**City of Bellevue  
Development Services Department  
Land Use Staff Report**

**Proposal Name:** EPC Holdings

**Proposal Description:** Proposal to modify a steep slope buffer and steep slope structure setback to construct a single-family residence, elevated motor court, and driveway. The proposal includes steep slope and buffer mitigation plan with native steep slope buffer planting.

**File Number:** 18-127150-LO

SITE PLAN

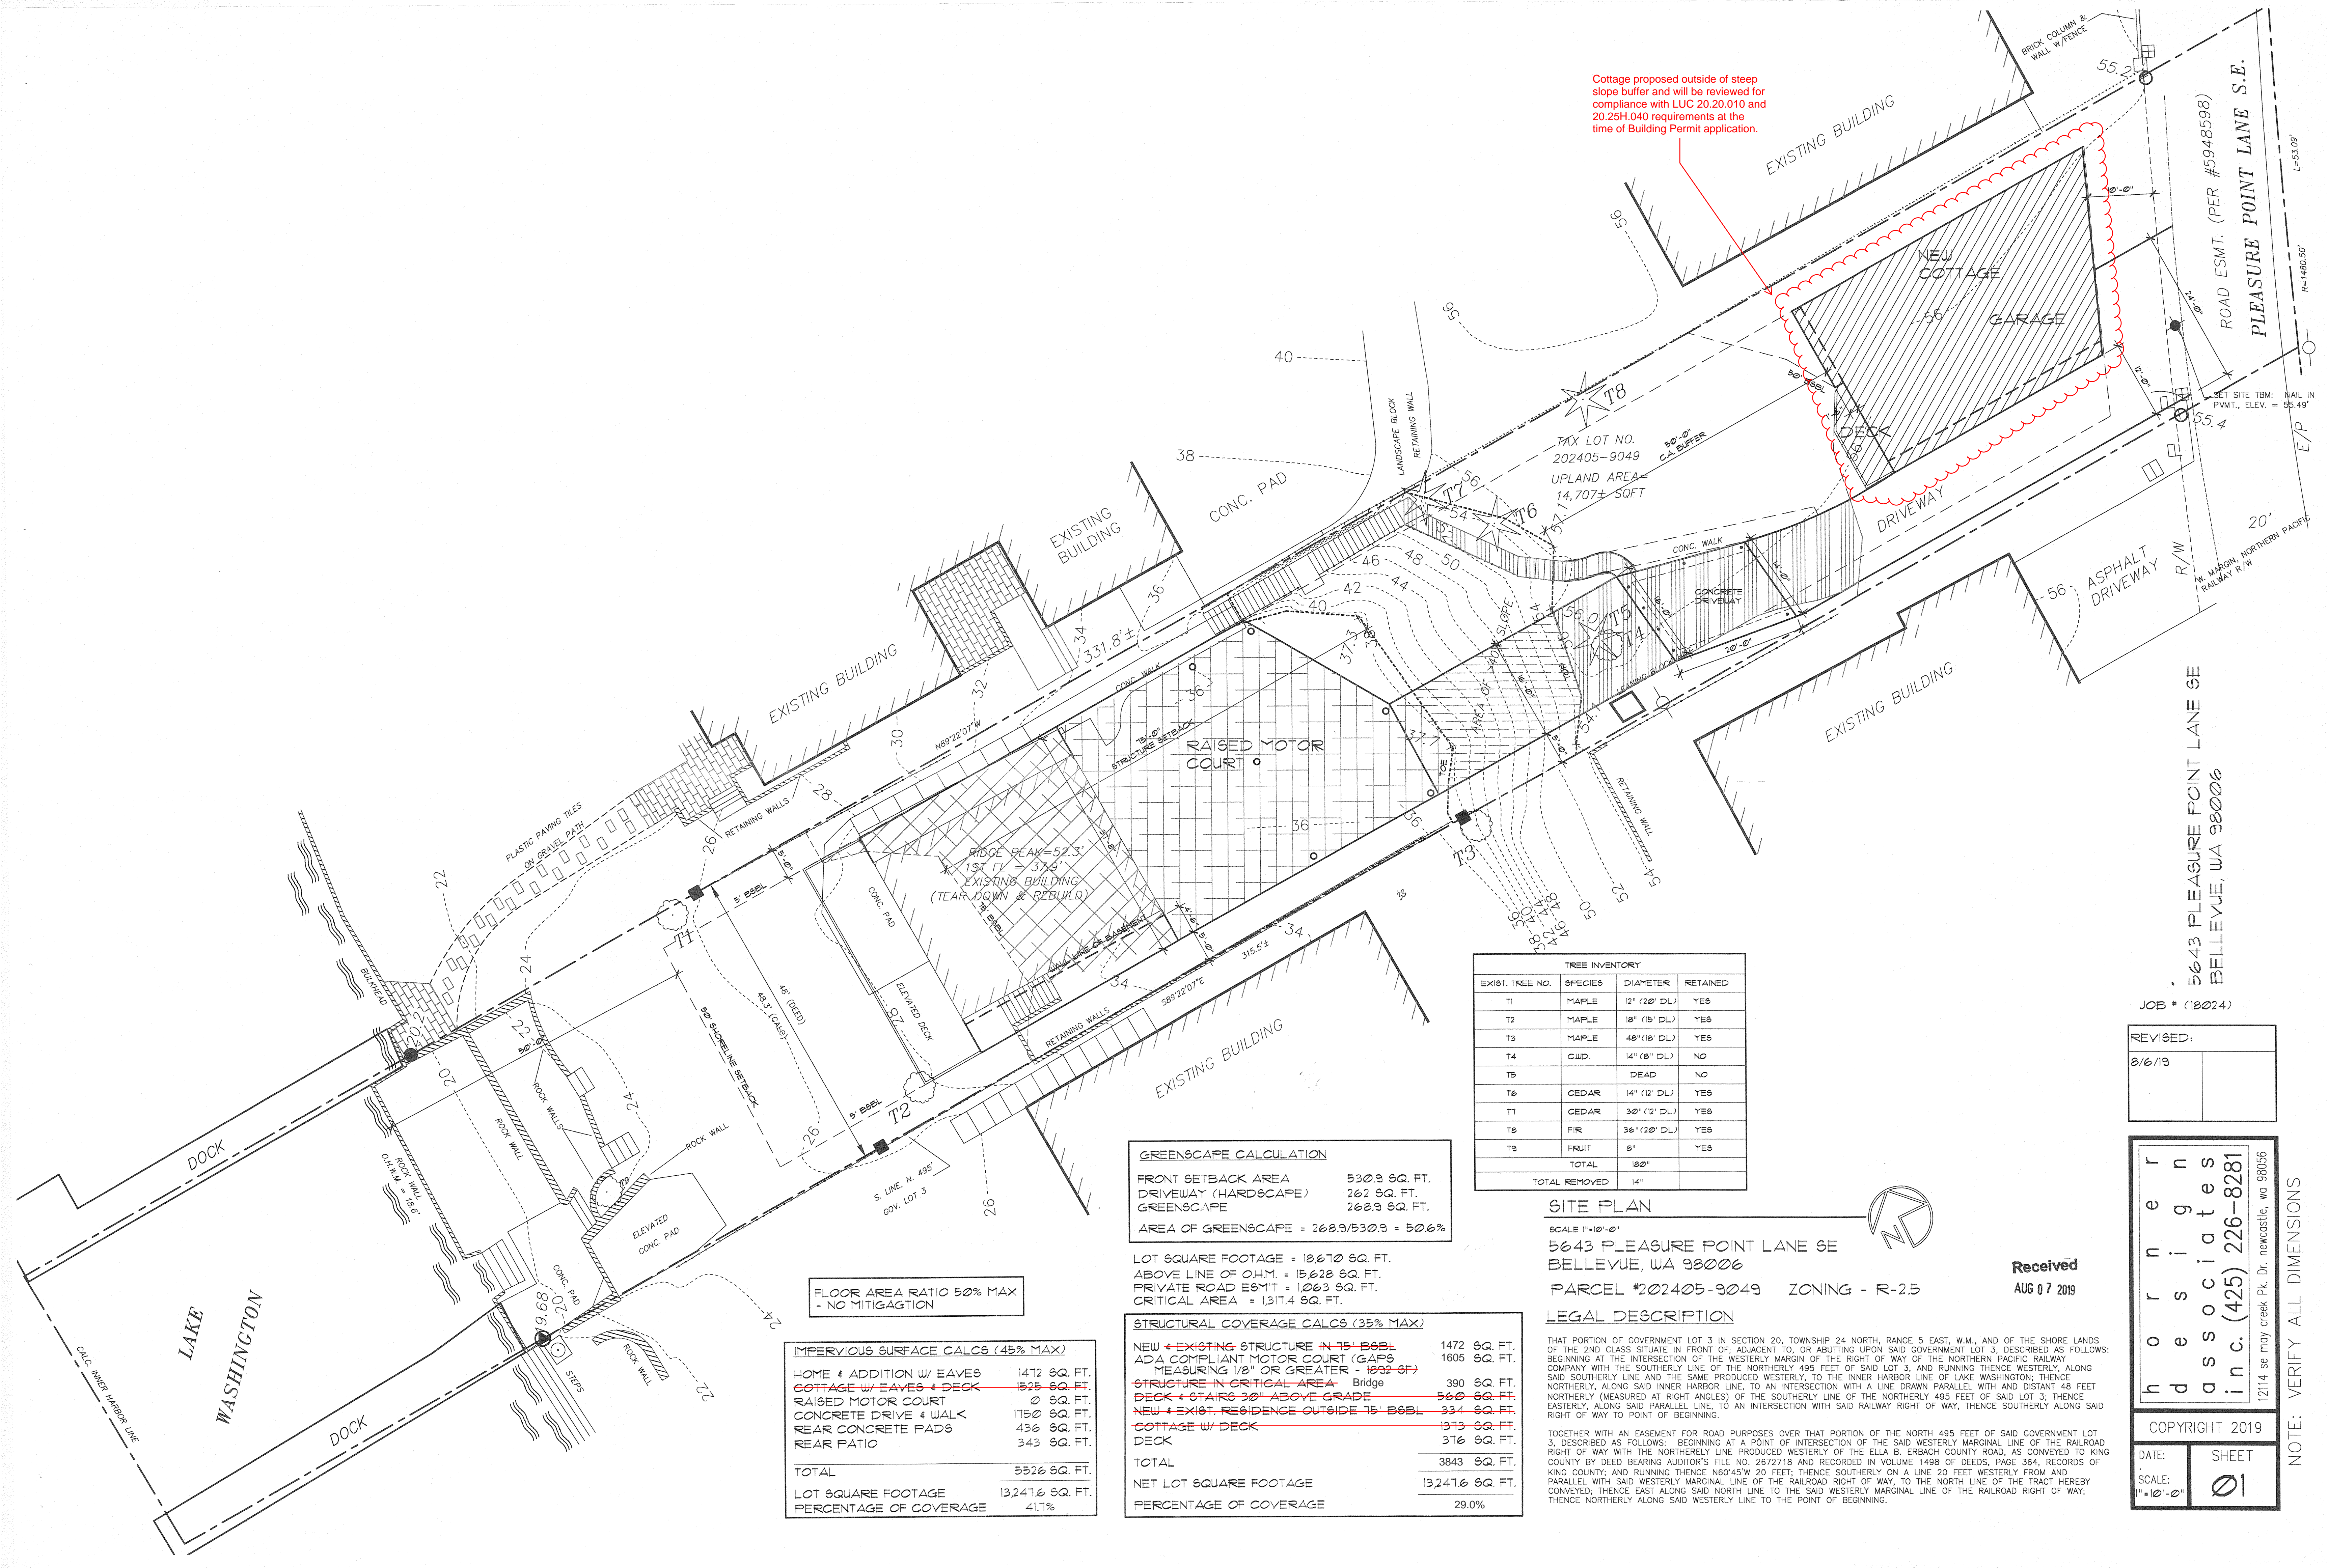
The applicant was requested to remove all notation of a proposed guest cottage from the plan due to its proposed location being outside of the critical area, critical area buffer, and critical area structure setback. Construction of a guest cottage outside of these regulated areas is subject to a building permit and must meet all general dimensional requirements of LUC 20.20.010 or modified requirements under LUC 20.25H.040. Compliance with these standards will be determined under the building permit application.

Cottage proposed outside of steep slope buffer and will be reviewed for compliance with LUC 20.20.010 and 20.25H.040 requirements at the time of Building Permit application.

PLANTING MITIGATION PLAN

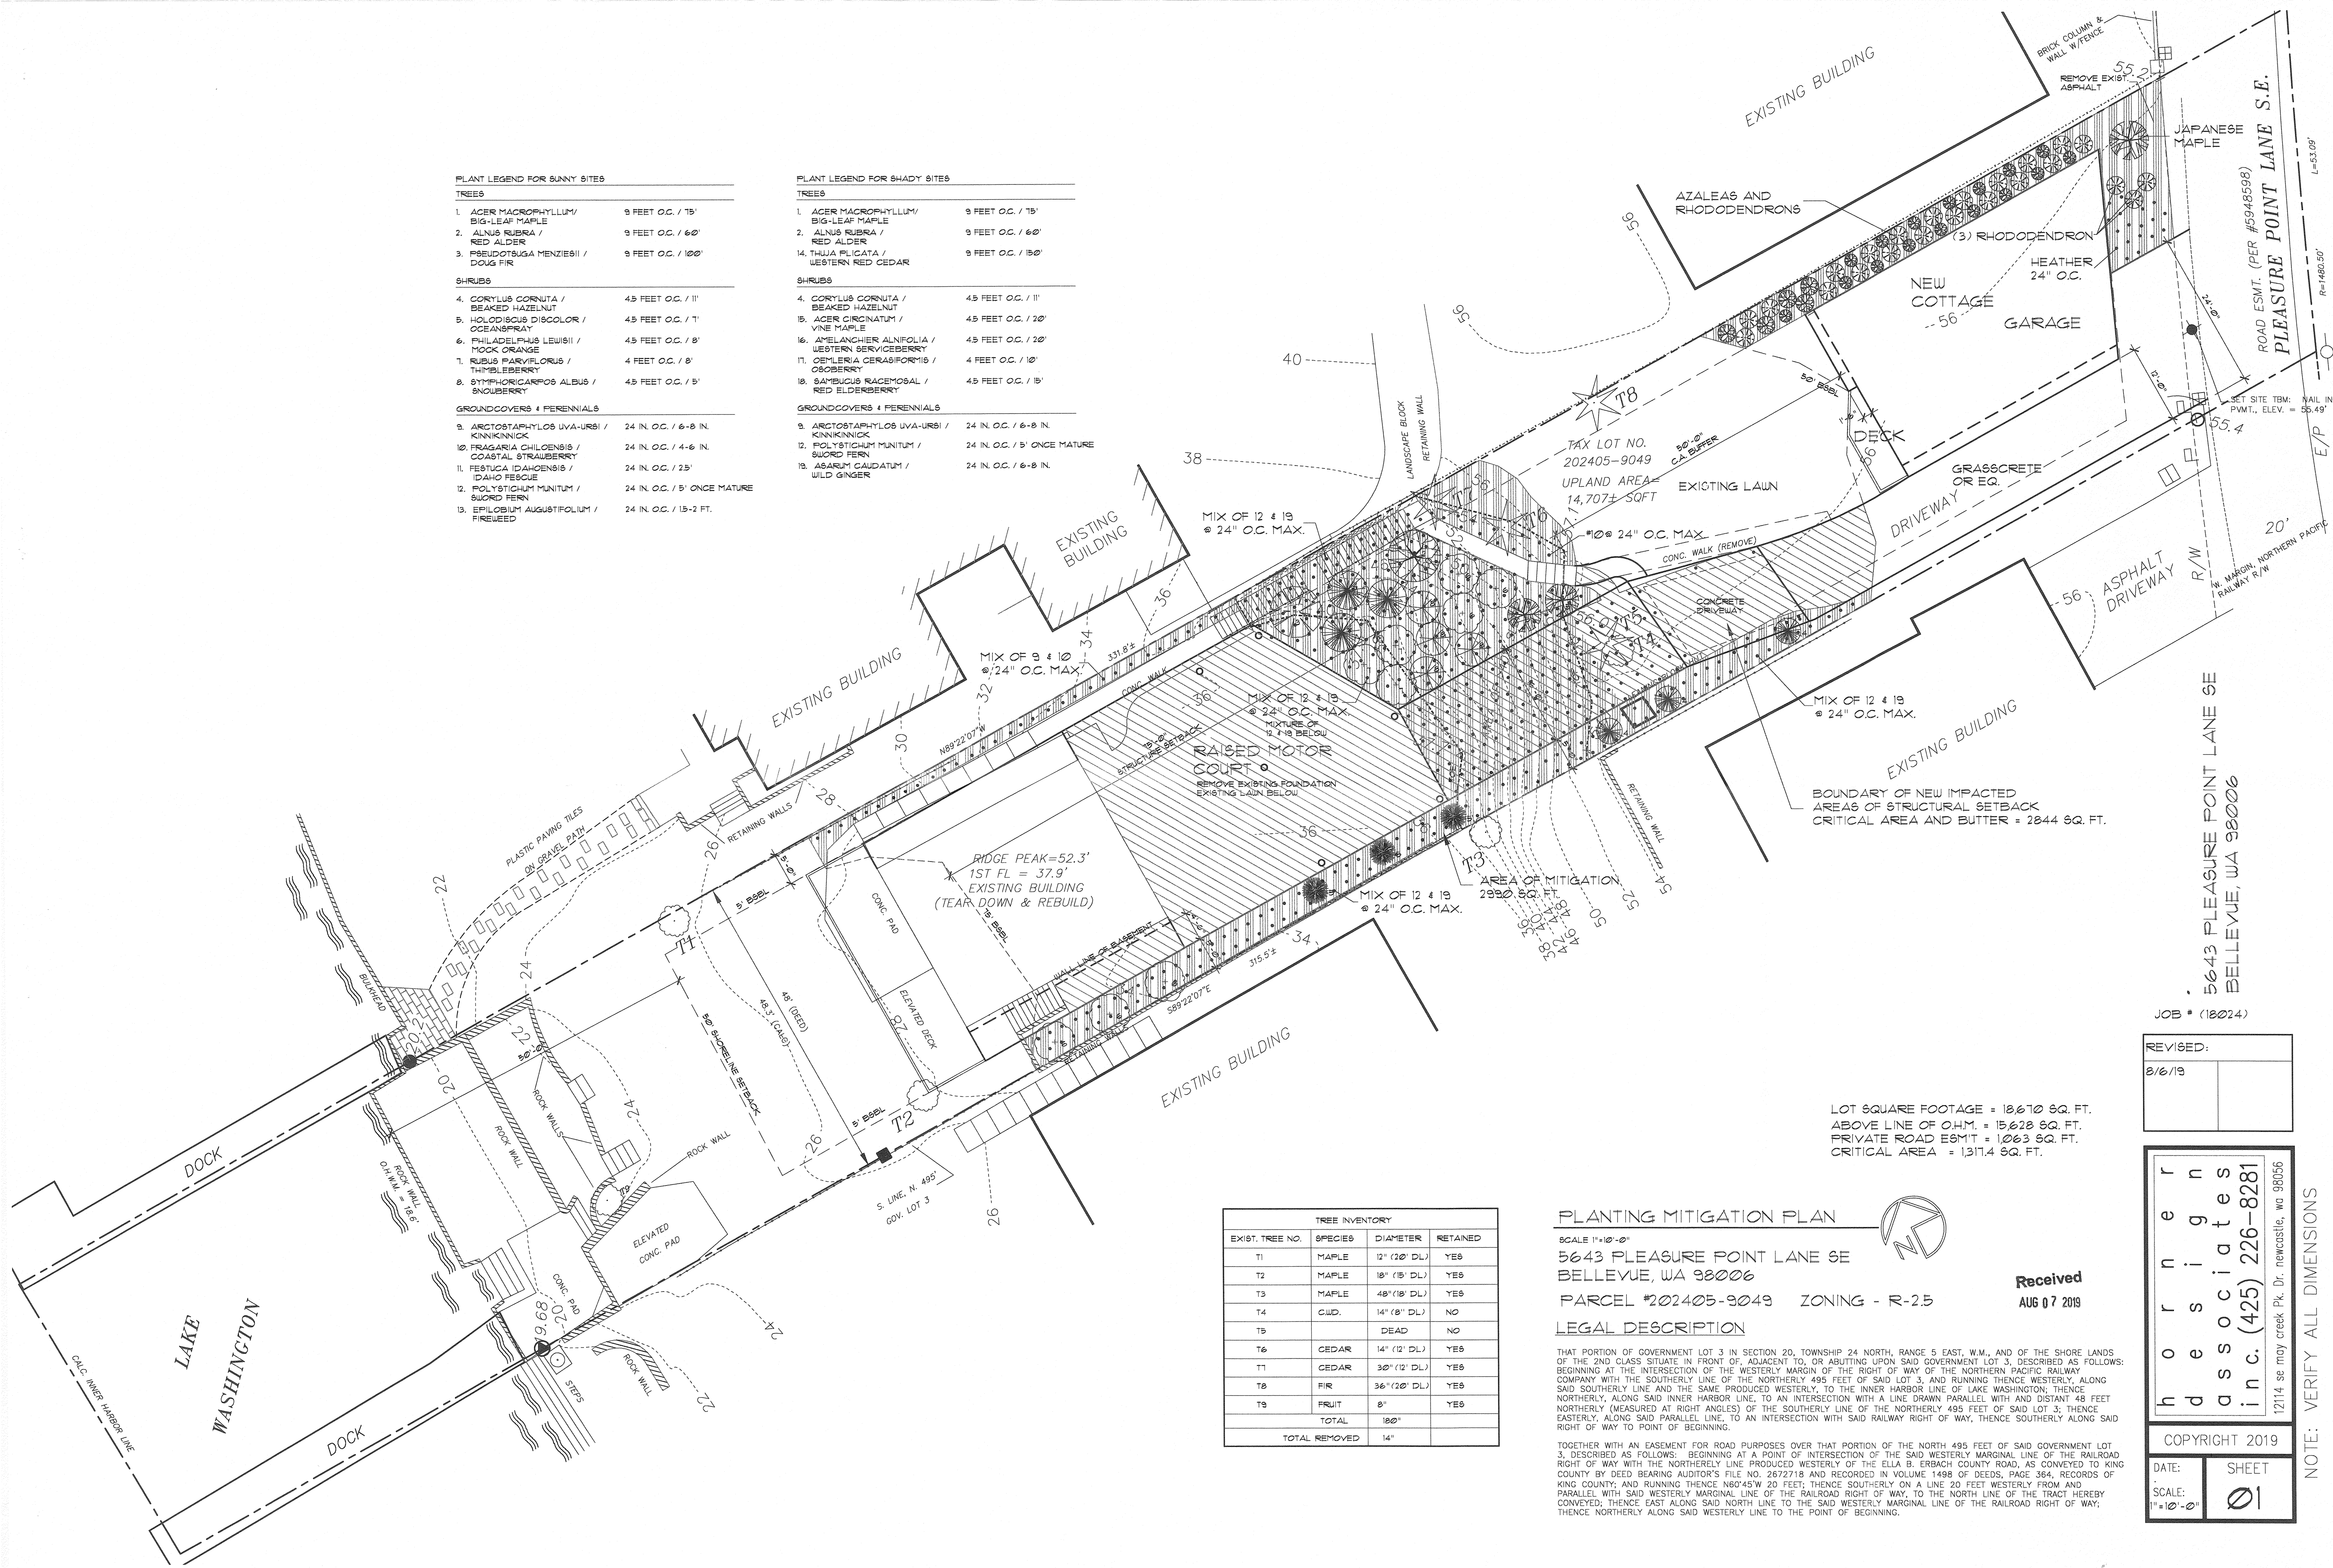
**2. Final Mitigation Plan:** A final mitigation plan in accordance with the conceptual mitigation plan provided under this application shall be submitted for review and approval by the City of Bellevue prior to issuance of the Building Permit. The plan shall document the total area of new critical area, buffer, and structure setback planting and shall be consistent with the guidance provided in the City's Critical Areas Handbook.

**3. Tree Removal:** Tree removal required for location the proposed improvements will need be mitigated at a 1:1 ratio and included within the Final Mitigation Plan supplied to the City at the time of the Building Permit.
